# Access Compliance Report

## Public Rights-of-Way

Intersection ID: 16599	Main Street: AMITY_PL	Cross Street: REDDMAN_RD	Location: SW
ADA ID: EFDB5C85A9D8	Ramp Type: BlendTrans2	Initial Pass/Fail: Fail	Overall Compliance: No
		Severity Score: 8.75

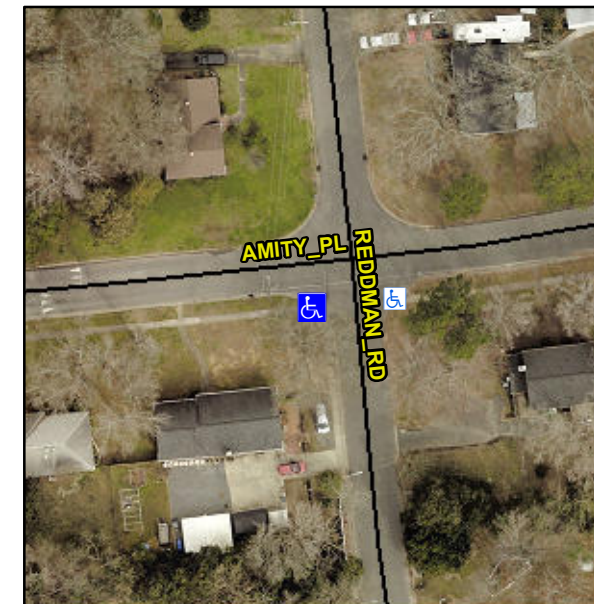
**Not Found, R304.5.1**

Compliance	Description	Data	Compliance	Description	Data
N/A	Ramp Length (in)	49.0	Yes	BlendTrans Slope (%)	1.9
No	Ramp Width (in)	39.0	Yes	BlendTrans XSlope (%)	1.1
N/A	Flare Type LT	N/A	N/A	Flare Type RT	N/A
N/A	Flare Slope LT (%)	N/A	N/A	Flare Slope RT (%)	N/A
N/A	Flare Traversable LT?	N/A	N/A	Flare Traversable RT?	N/A
N/A	Landing Length (in)	N/A	N/A	DWS Provided?	N/A
N/A	Landing Width (in)	N/A	N/A	DWS Contrast?	N/A
N/A	Landing Slope (%)	N/A	N/A	DWS Length (in)	N/A
N/A	Landing X Slope (%)	N/A	N/A	DWS Full Width?	N/A
N/A	Landing Curb? (Y/N)	N/A	N/A	DWS Offset (in)	N/A
N/A	Shared Landing?	N/A			
N/A	Gutter Ponding?	N/A	N/A	Gutter Slope (%)	N/A
N/A	Gutter Lip Ht (in)	N/A	N/A	Gutter X Slope (%)	N/A
N/A	Painted X Walk1?	No	N/A	Painted X Walk2?	No
	X Walk 1 Direction	To E		X Walk 2 Direction	To N
	X Walk 1 Width (in)	N/A		X Walk 2 Width (in)	N/A
	X Walk 1 Slope (%)	2.2		X Walk 2 Slope (%)	5.1
	X Walk 1 X Slope (%)	3.8		X Walk 2 X Slope (%)	1.6

N/A	Ramp inside XWalk1?	N/A	N/A	Ramp inside XWalk2?	N/A
	Road Slope (%)	1.2		Clear Space?	N/A
	Road X Slope (%)	5.5	N/A	Clear Space to XWalk (in)	N/A
N/A	Any Obstructions?	N/A	N/A	Storm Grate/Utility Hazard?	N/A
	Obstruction Type			Storm Grate/Utility Type	
		N/A			N/A
			Yes	Surface Condition? (G/P)	Good
			No	Curb Slope (%)	15.1

**Remove & Replace Curb Ramp With Two New Directional Ramps or Equivalent.**
